FLORIDA DEPARTMENT OF AGRICULTURE AND CONSUMER SERVICES COMMISSIONER ADAM H. PUTNAM

ADDENDUM 1

TO: Vendors
FROM: Vianka Colin, Purchasing Director
**RE: INVITATION TO BID NUMBER ITB/DA-17/18-32
ROOFTOP HVAC REPLACEMENT**

Florida Department of Agriculture and Consumer Services
ROOFTOP HVAC REPLACEMENT
DOYLE CONNER LAB ADMIN. BUILDING

SHEET TITLE:
MECHANICAL
SECOND FLOOR
NEW WORK

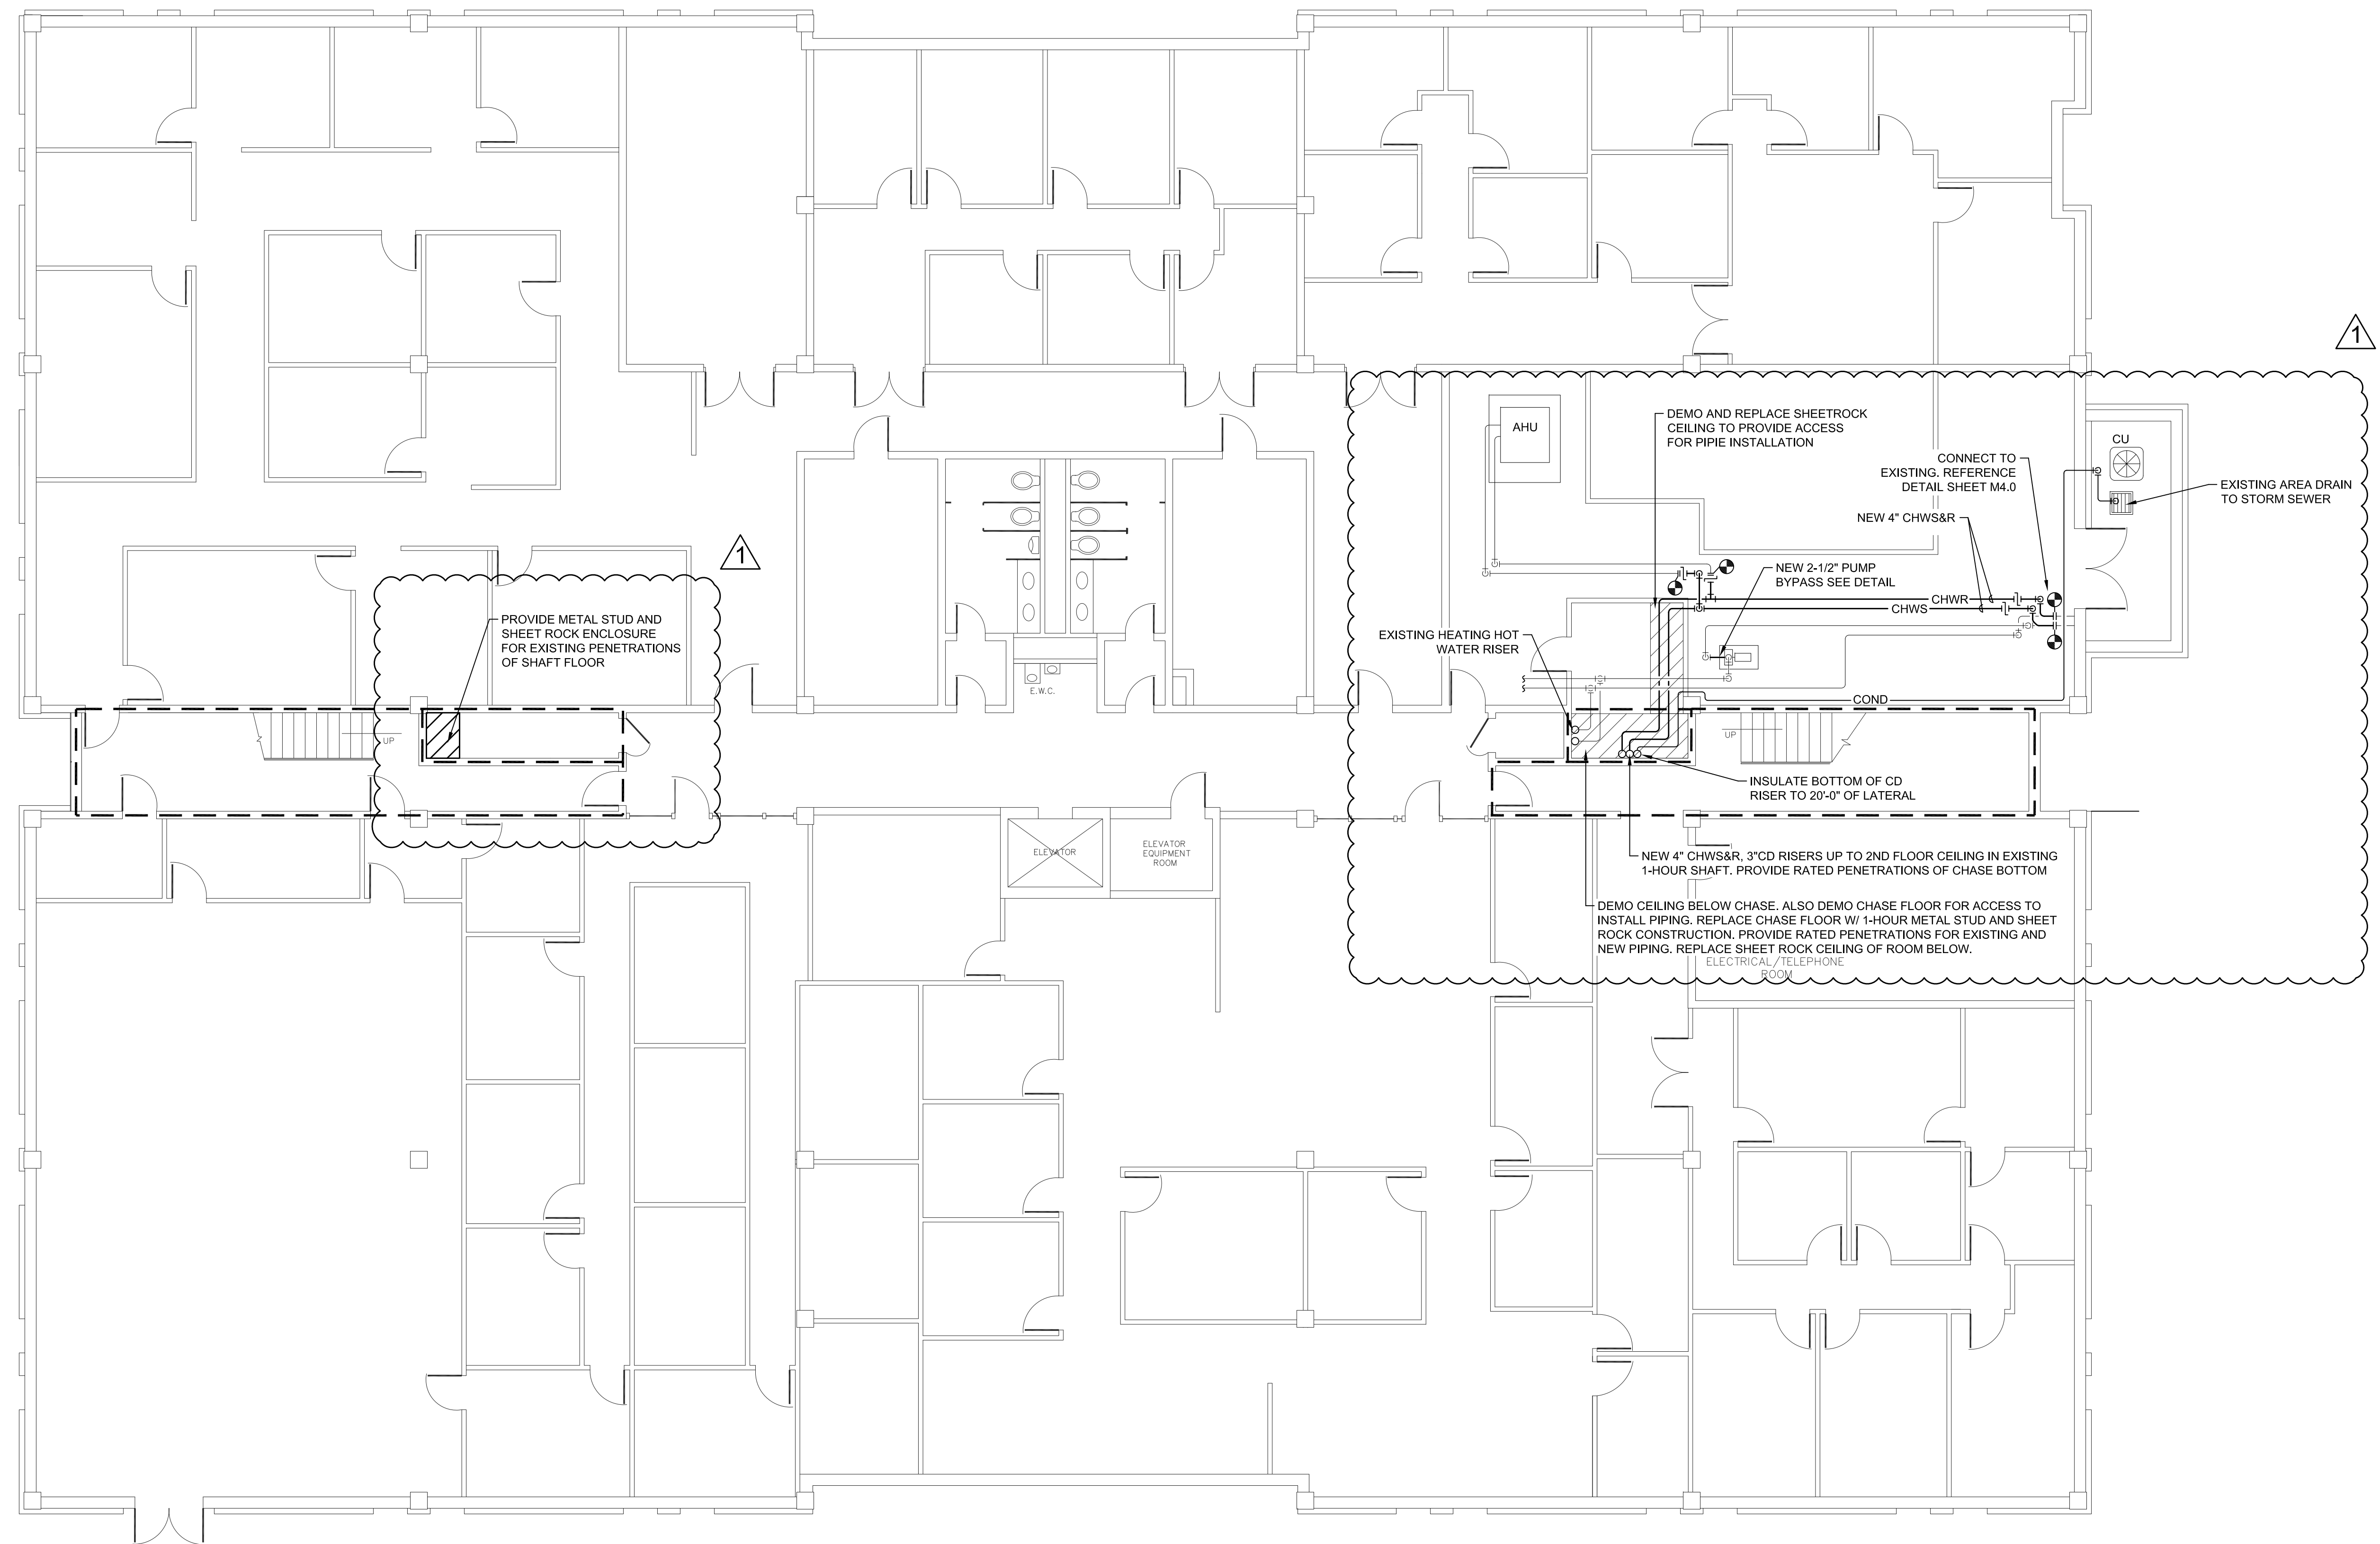
1. **Drawing M3.0 shows us extending the existing 6" chilled water (CW) piping. The point of connection to extend the 6" CW pipe is 4". Please provide the location where we are to pick up the 6" CW from?**

2. **Drawing M3.1 shows us routing the new CW piping above the ceiling towards two shaft locations. Through the site visit, it was discovered that the existing ductwork takes up the entire space from ceiling grid to the concrete deck in multiple locations. There will not be enough room to blow-out the ductwork to accommodate the new CW piping. Please provide some direction on how to proceed.**

1. Chilled water piping & connection size has been revised
2. Chilled water pipe routing has been revised.
3. Condensate pipe routing has been revised, French drains have been eliminated.
4. Demolition of shaft bottom for access has been indicated
5. Reconstruction of 1-hour shaft bottom has been detailed

Connection is to be made at the available 4" piping located in the main mechanical room. See Revised Drawings.

The revised pipe routing avoids the conflicts described and simplifies the vertical pipe routing. See Revised Drawings for revised pipe routing.
